This is to request a Class II permissive change for FCC ID: **2BFTG-CEFLA** originally granted on **08/27/2026**.

Product Name: Intraoral Scanner

Model Number: MyScan Air, ViSIOScan Go, AlphaScan 3, OptiScan 3

● **Appearance comparison photo**

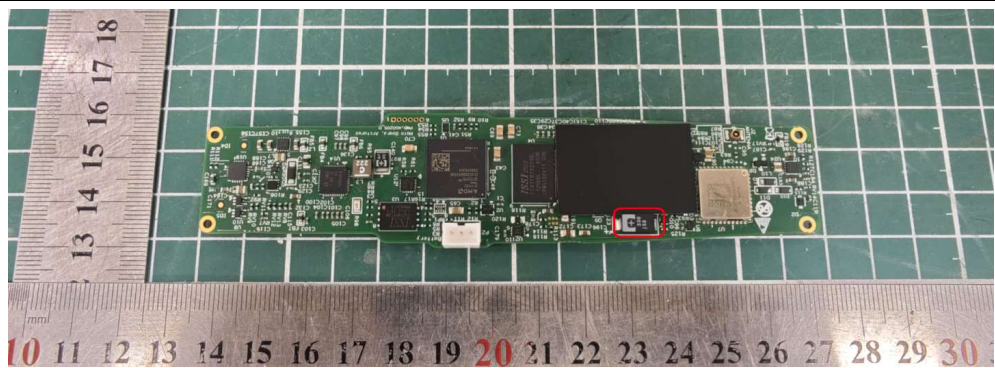
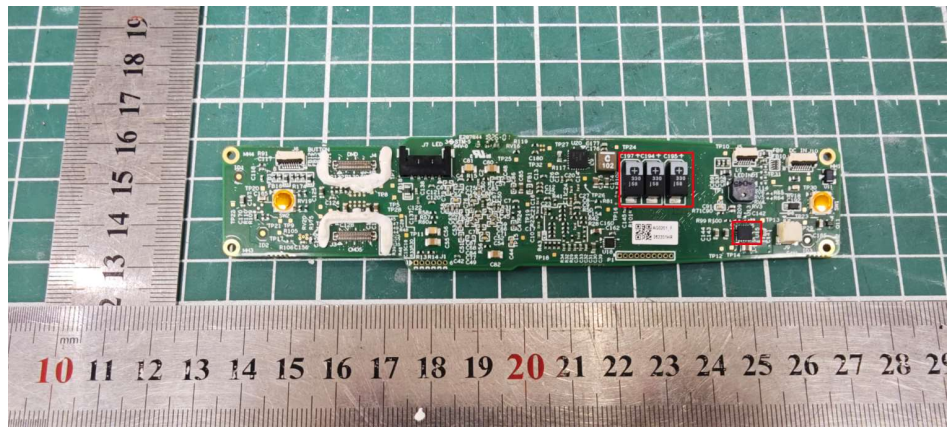
- The scanner buttons are different in appearance. The buttons on MyScan Air, ViSIOScan Go, AlphaScan 3, and OptiScan 3 are made of silicone material;
- The charging holder has a slightly modified external appearance;
- The bottom appearance of the handheld scanner has been slightly modified.
- The capacitor has been switched from the super capacitor (U23, Version D) to 4 polymer solid

● Internal comparison photo

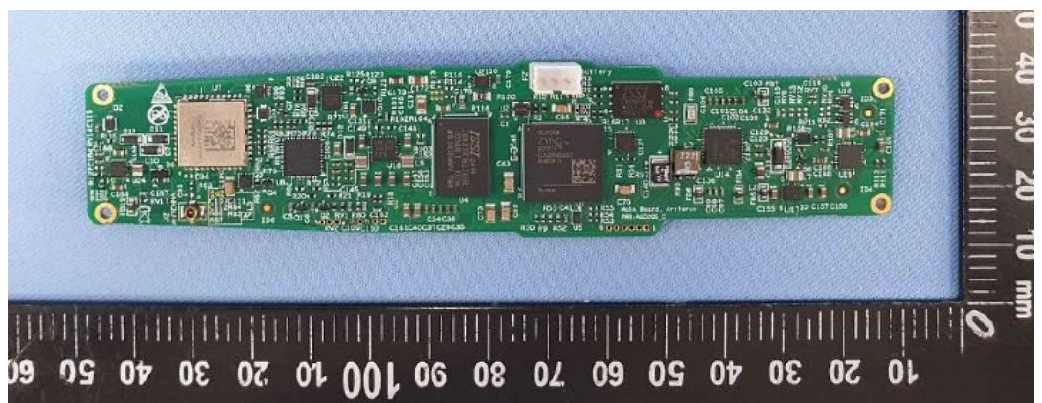
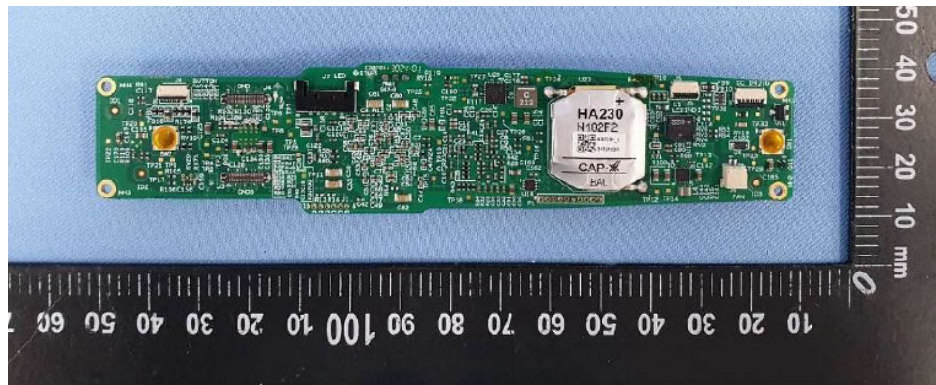
tantalum capacitors(C194-C197, Version E), and the corresponding supporting circuitry for the capacitors has been adjusted.

- The power IC has been switched from TPS63030 (U15, Version D) to the same series TPS63000 (U15, Version E), increasing the maximum output current from 800mA to 1200mA.
-
